ADDENDUM

ADDENDUM NO: 1
PROJECT TITLE: Peoria PlayHouse
Children's Museum
Renovation

ISSUANCE DATE: February 12, 2026
LOCATION: Peoria PlayHouse

SHEET TITLE:
BASEMENT FLOOR PLAN

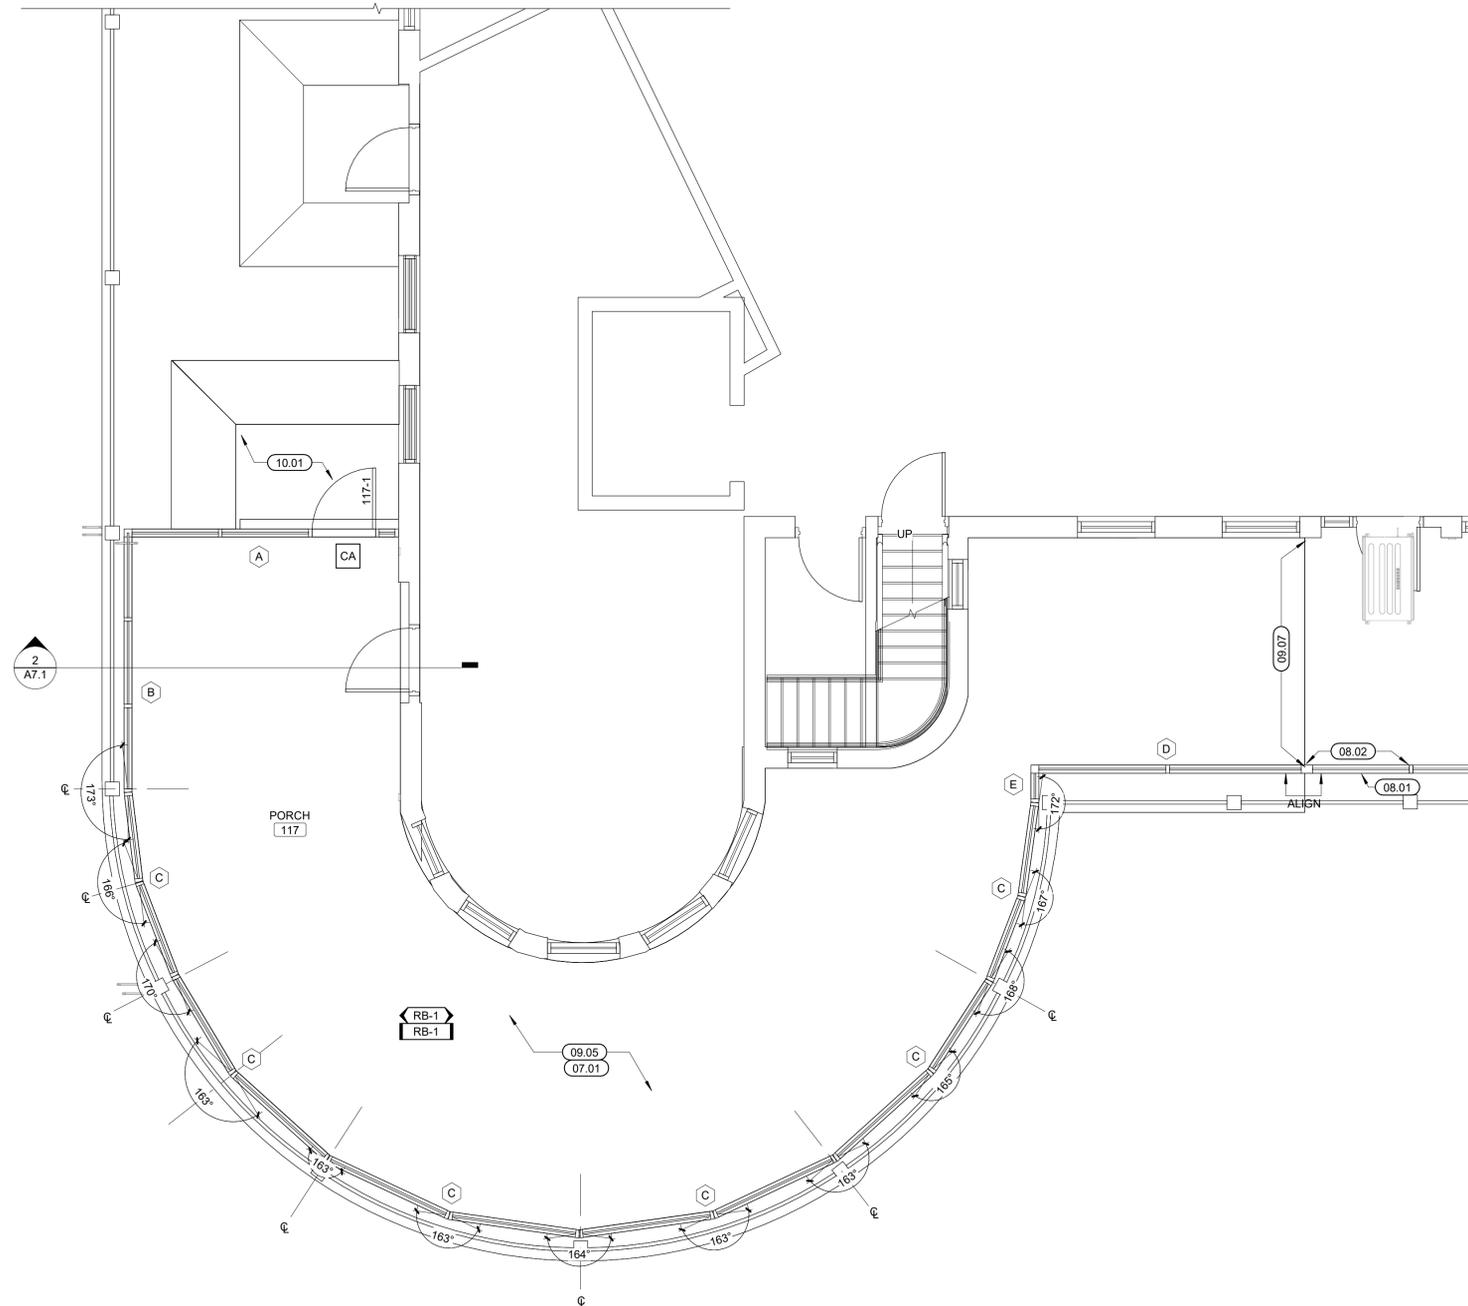
1. Sheet A1.0 - BASEMENT FLOOR PLAN
 - a. REVISE "RB-3" to "WB-3".
2. Sheet A1.1 - FIRST FLOOR PLAN
 - a. Reference Overall Product Finish Schedule:
 - i. REMOVE "RB-3" and ADD "WB-3" and associated information.
 - ii. ADD note 4
